FCO Application

Field Change Order Number: LX5XX-XX-0001

Field Change Order Name: Prioris LX5000 RTC

Applicability: Prioris LX Models FR944WW / LX5150, FR945WW / LX5200

Figure 3-15. Installing the Server Battery

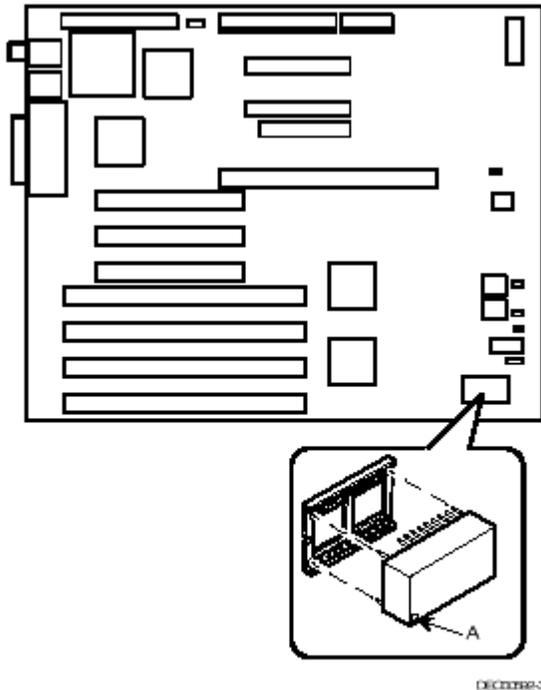
- return to the main menu and exit.
2. Power off your server.
3. Unlock and remove the left side panel.
4. Remove the RTC chip (ref. to Fig 3.15 below)
5. Install the new RTC chip (ref. to Fig 3.15 below).

- The RTC assembly supplied in the FCO kit can be identified by the small surface mount resistor and green ECO wire on the bottom of the RTC chip between pins 15 and 24.

CAUTION: Make sure pin 1 on the battery is correctly aligned with the pin 1 location on the socket (A, Figure 3-15). The pin 1 location on the battery is designated by a (white) dot in the lower left corner of the battery. Incorrect installation may cause faulty server operation.

Solution: Replace the RTC chip E48 with a RTC assembly (part number **70-33198-01**) per ECO 5423048-TA019.
